PLANNING COMMITTEE – 3 JULY 2018

Application No:	18/00126/LBC	
Proposal:	Proposed conversion of Hatton House (formerly Newark Working Mens Club) Beacon Hill Road Newark, to form 8 apartments. Remainder of building to be demolished. To include erection of 8 new cottages and associated access and landscaping works.	
Location:	Newark Working Men’s Club, 13 Beacon Hill Road, Newark On Trent	
Applicant:	Northgate Lettings	
Registered:	19 January 2018	Target Date: 16 March 2018

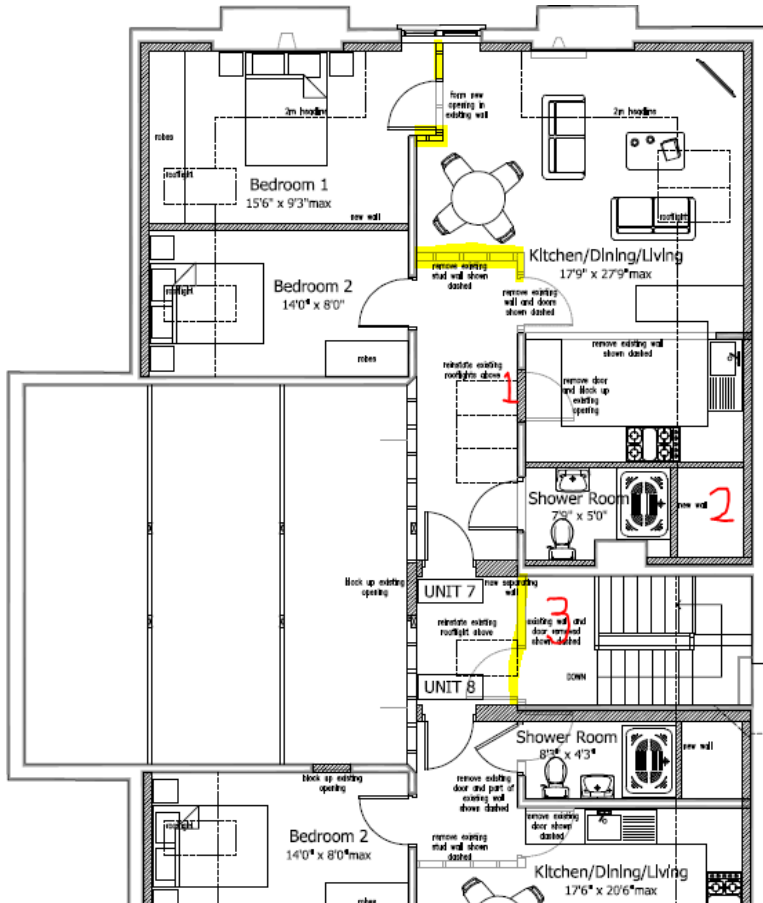
My main issue with this first floor layout is the way the reinstatement of the grand staircase will be compromised by bringing forward rooms right up the banister, removing the landing, as marked with the blue zigzag line and number 1. This will crowd the staircase and undermine the ostentatious sense of space (and circulation) that it was designed to bring. I have spoken to the owner about this specifically and accept there needs to be some form of easement to keep access across the landing to the flats, but that this can be achieved by a chamfered corner, as marked number 2 above, leaving most of the original landing open. This will complete the positive impact of reinstating the grand staircase.

I am also not happy at the proposed ensuite across a fireplace (marked number 3 above). I do appreciate an existing inappropriate stud wall here, but the removal of this and reinstatement of the fireplace as a proper feature will be a positive enhancement which could be achieved here. The compromise is the need to achieve bathroom space and I feel this is best achieved by creating a 'Jack and Jill' style arrangement as marked number 4 above. Overall, I think this will be a better arrangement than is currently at the building and a reasonable compromise moving forward. What we didn't discuss on site, but which could be looked at, is whether the floor to ceiling height is such that this ensuite could be formed more as a pod, sitting under the original ceiling height allowing the original layout of the room to be read. The other option, which was used at St Pancras Station Hotel and put forward in the recent Kelham Hall application, is to create a bespoke bed which has an ensuite behind, almost like a fitted wardrobe, although I appreciate this may be more appropriate for hotels than for residential properties.
